ATTACHMENT B

NIAGARA MOHAWK POWER CORPORATION

LICENSE NO DPR-63

Supporting Information and No Significant Hazards Consideration Analysis

Figure 3.1.2b

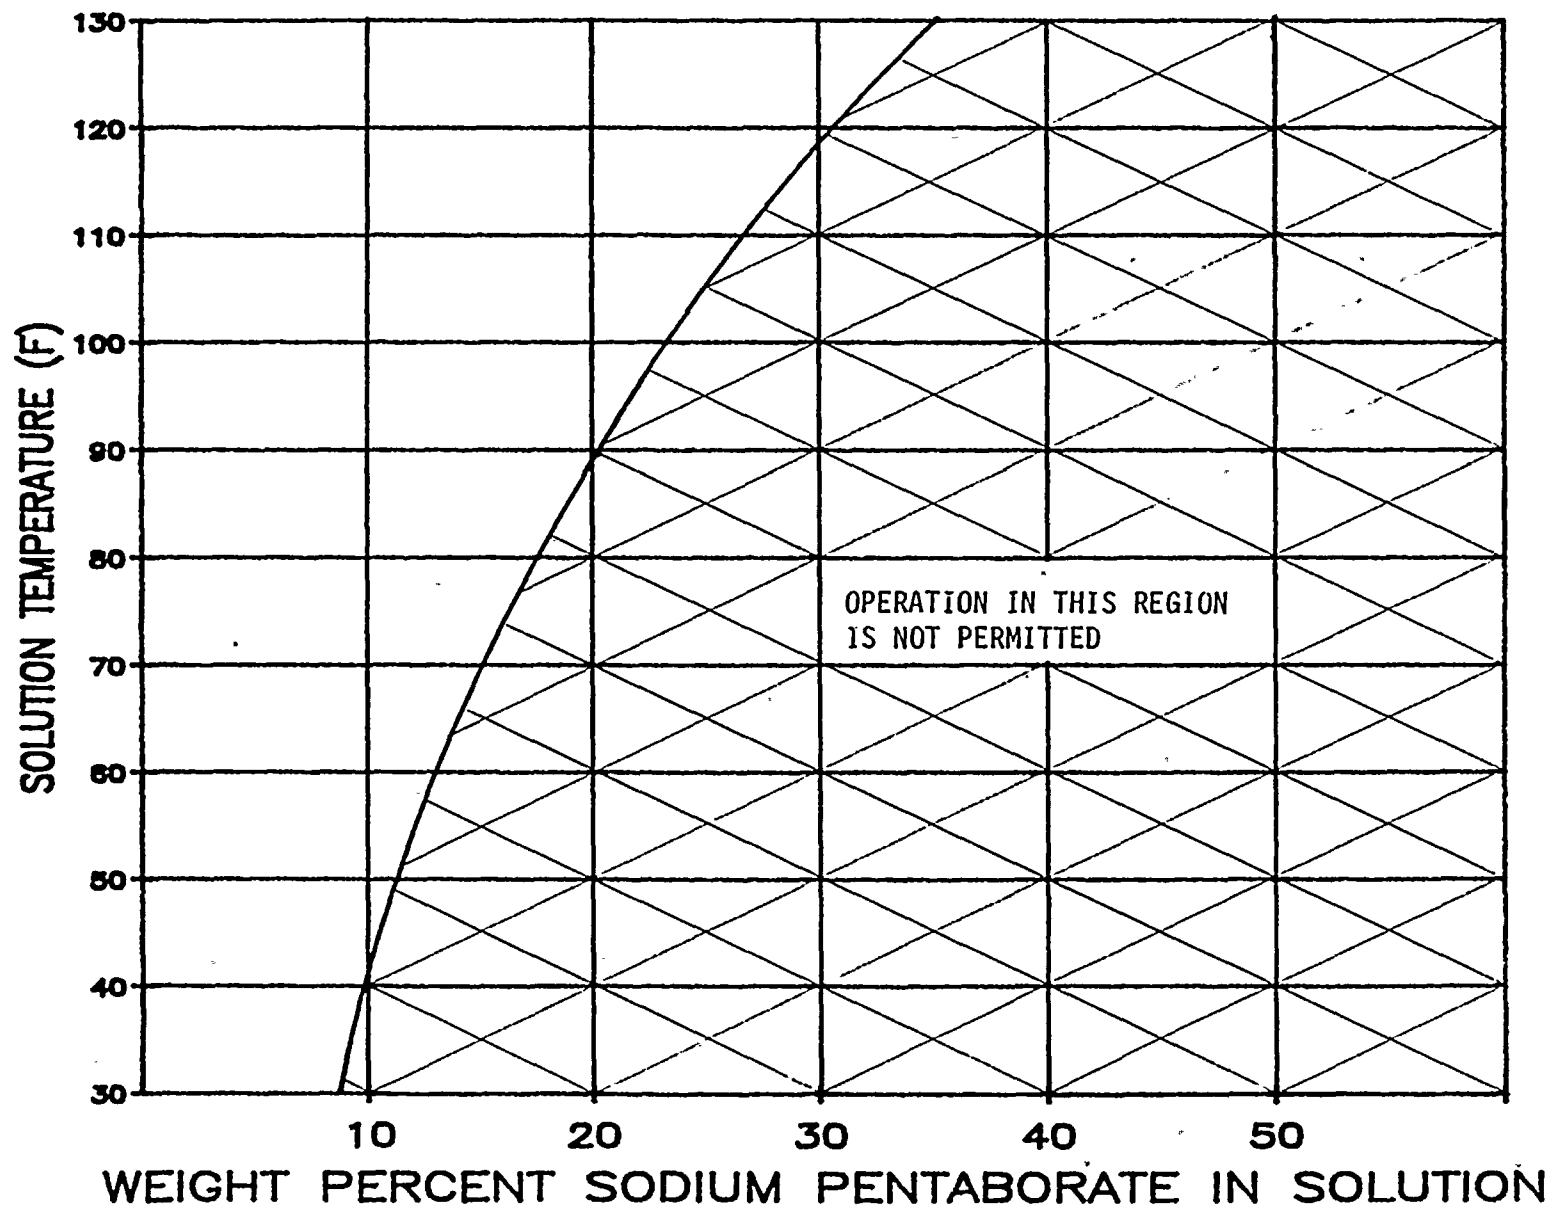
The solution saturation temperature varies with the concentration of sodium pentaborate. Figure 3.1.2.b. includes a 5F margin above the saturation temperature to guard against precipitation. Temperature and liquid level alarms for the system are annunciated in the Control Room.

Figure 3.1.2.b has been redrawn to include lower temperatures and lower concentrations of sodium pentaborate.
